Municipal Planning Commission

AGENDA

Monday, April 3, 2023 — 7:00

SUBJECT: Master Plan Application Review

FINAL PLAT
SHEET 1 OF 2
PHASE ONE-B
JOYCE'S GARDENS SUBDIVISION
BARTLETT, TENNESSEE

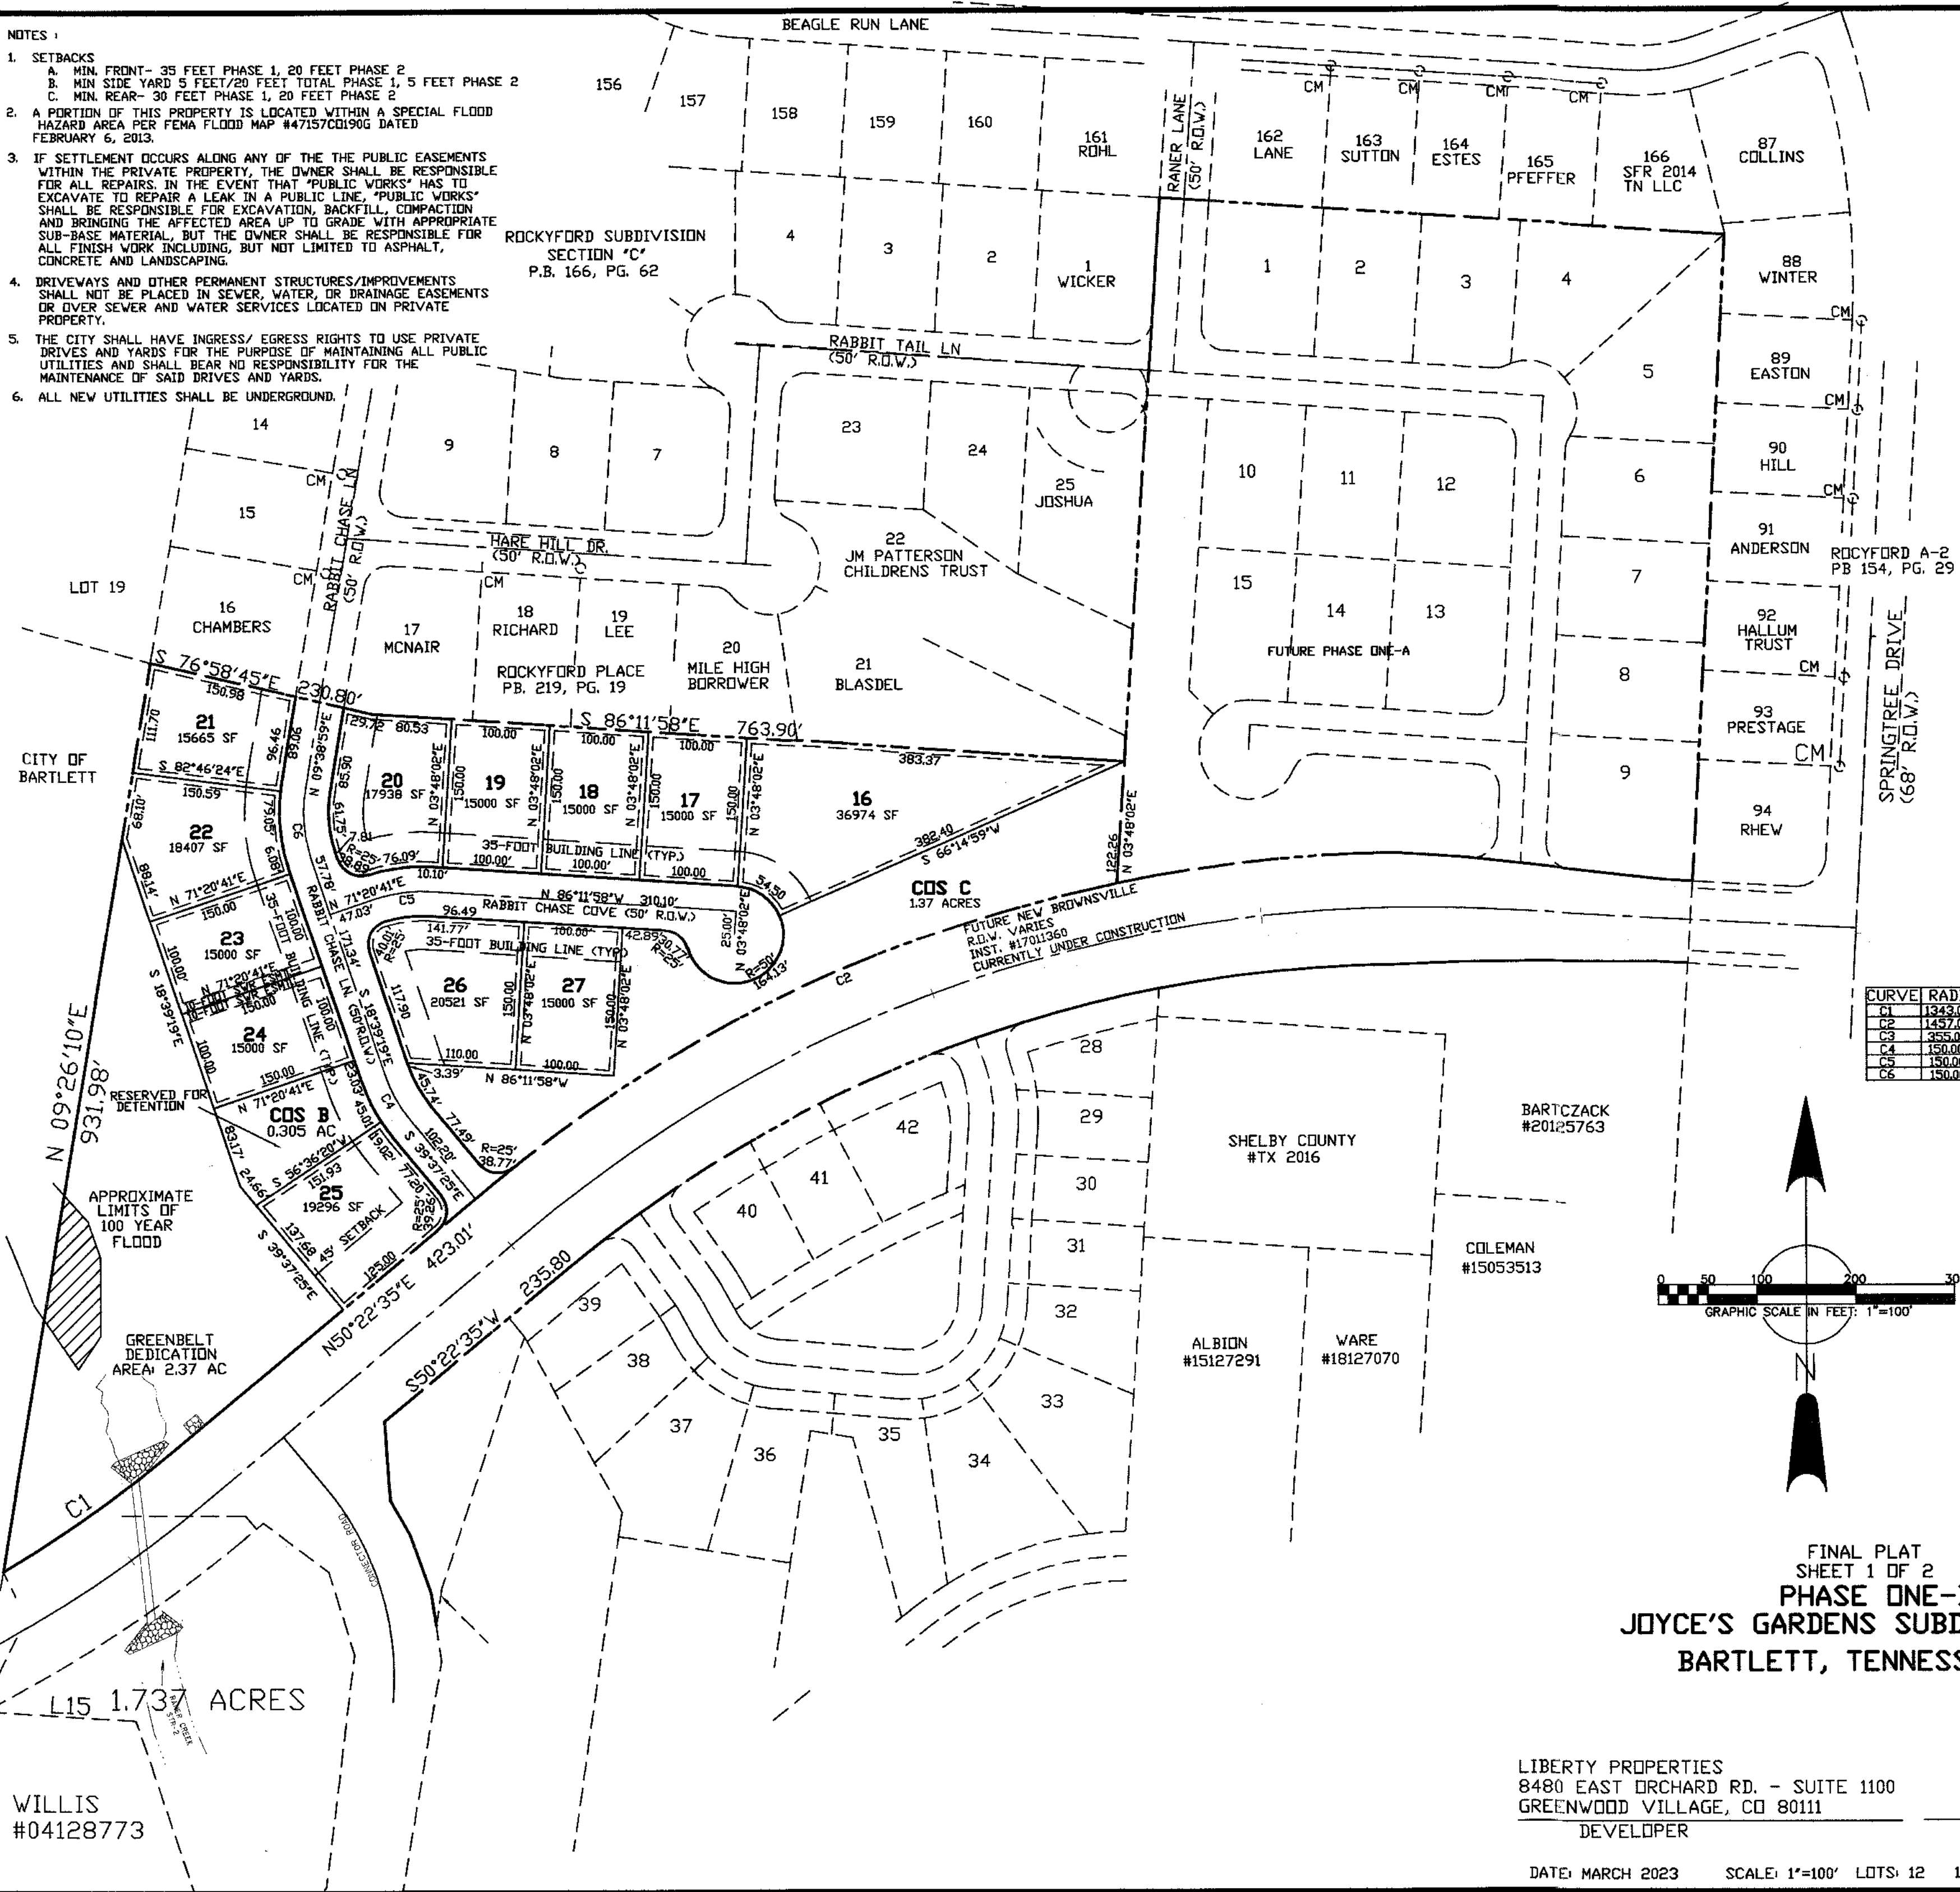
1. A full subdivision contract will be required.
2. All new utilities shall be underground.
3. Handicap ramps are required at street corners.
4. Lot 25 will be restricted from access to New Brownsville Road.
5. All mark-ups and corrections shall be addressed on the revised plans.
6. Construction access will not be permitted on New Brownsville until the road-way is finished and released to the City of Bartlett.
7. COS sidewalk shall be installed during site construction.
8. Tree survey is required.

9. Traffic Control Plan will be required.
10. Street signage shall be added to plans.
11. Utilities requiring work in New Brownsville road must be bored.

12. All COS shall be maintained by the Homeowners Association. This includes the detention basin and outlet structure.
13. Drainage easement shall be shown in COS B to include the pipe and structure 4 into the detention basin as well as structure 2 and the pipe out of the detention basin.
14. Sidewalk table shall be added. Sidewalk on New Brownsville Road are 8 feet wide.
15. Show location of subdivision concrete monuments to be installed as required by the subdivision ordinance.

1. The applicant shall rename the subdivision to Joyce's Gardens Planned Development since this development is being approved as a planned development in lieu of a standard subdivision.

2. The applicant shall rename COS C to COS A since COS C is included in Phase 2.
3. The applicant will need to add a note to the plat to deny driveway access to New Brownsville Road for Lots 25 and COS A.

5. The applicant shall add a condition to the plat as well as within the restrictive covenants to prohibit RV, boat, trailer, and the like storage within Joyce's Gardens Planned Development.
